APPLICATION NO.	FILING DATE	FIRST NAMED INVENTOR	ATTORNEY DOCKET NO.	CONFIRMATION NO.
10/535,718	08/05/2005	Henri Van Der Knokke	P/22-258	7713
2352 7590 01/04/2007 OSTROLENK FABER GERB & SOFFEN 1180 AVENUE OF THE AMERICAS NEW YORK, NY 100368403			EXAMINER DUNLAP, JONATHAN M	
			ART UNIT	PAPER NUMBER
			2112	
SHORTENED STATUTORY PERIOD OF RESPONSE		MAIL DATE	DELIVERY MODE	
3 MONTHS		01/04/2007	PAPER

Office Action Summary

DETAILED ACTION

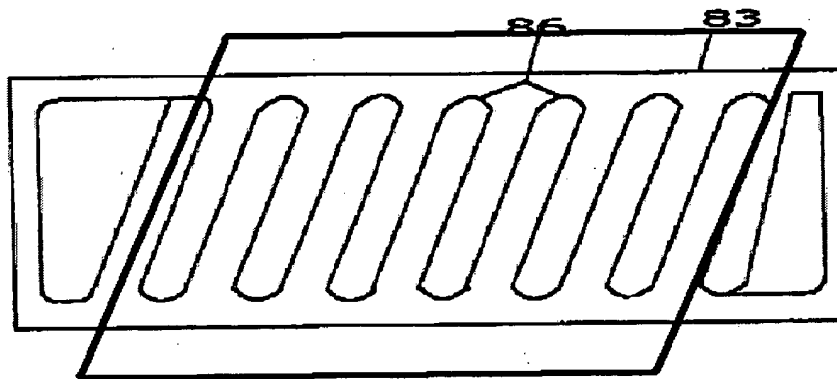
5. However, Keck teaches:

- Strain gauge sensors that comprise a plurality of adjacent conductor track sections **5 (Figure 2; Column 3, lines 5-12);** and
- The lengths of two adjacent ones of the conductor track **5** sections of the strain gauge sensor differ (**Figure 2**).

Therefore, it would have been obvious to a person of ordinary skill in the art at the time the invention was made to included a strain gauge having a plurality of adjacent conductor tracks sections with the lengths of two adjacent ones of the track sections being different as taught by Keck in the invention by Baully. The motivation for doing so was to provide a device to cover a larger area for sensing force (**Keck, Column 1, lines 25-33**).
